# Access Compliance Report

## Public Rights-of-Way

### (Curb Ramps)

Intersection ID: 2758	Main Street: BUCKSPRING_LN	Cross Street: SKYLINE_DR	Location: NW
ADA ID: B9D7F863C4E6	Ramp Type: PerpDiag	Initial Pass/Fail: Fail	Overall Compliance: No
Severity Score: 21.25			
Codes/Mitigation Info/Possible Solution		Field Measurements/Component Compliance

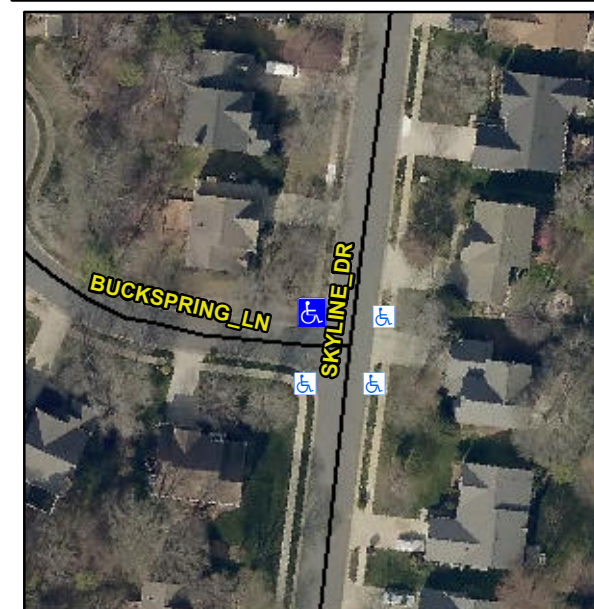
**R304.5.1, R304.5.3**

Compliance	Description	Data	Compliance	Description	Data
N/A	Ramp Length (in)	51.0	Yes	Ramp Slope (%)	7.9
No	Ramp Width (in)	38.0	No	Ramp XSlope (%)	5.3
N/A	Flare Type LT	N/A	N/A	Flare Type RT	N/A
N/A	Flare Slope LT (%)	N/A	N/A	Flare Slope RT (%)	N/A
N/A	Flare Traversable LT?	N/A	N/A	Flare Traversable RT?	N/A
N/A	Landing Length (in)	N/A	N/A	DWS Provided?	N/A
N/A	Landing Width (in)	N/A	N/A	DWS Contrast?	N/A
N/A	Landing Slope (%)	N/A	N/A	DWS Length (in)	N/A
N/A	Landing X Slope (%)	N/A	N/A	DWS Full Width?	N/A
N/A	Landing Curb? (Y/N)	N/A	N/A	DWS Offset (in)	N/A
N/A	Shared Landing?	N/A			
N/A	Gutter Ponding?	N/A	N/A	Gutter Slope (%)	N/A
N/A	Gutter Lip Ht (in)	N/A	N/A	Gutter X Slope (%)	N/A
N/A	Painted X Walk1?	No	N/A	Painted X Walk2?	No
	X Walk 1 Direction	To S		X Walk 2 Direction	To E
N/A	X Walk 1 Width (in)	N/A	N/A	X Walk 2 Width (in)	N/A
	X Walk 1 Slope (%)	2.8		X Walk 2 Slope (%)	3.1
	X Walk 1 X Slope (%)	3.4		X Walk 2 X Slope (%)	4.2

**Remove & Replace Curb Ramp With Two New Directional Ramps or Equivalent.**
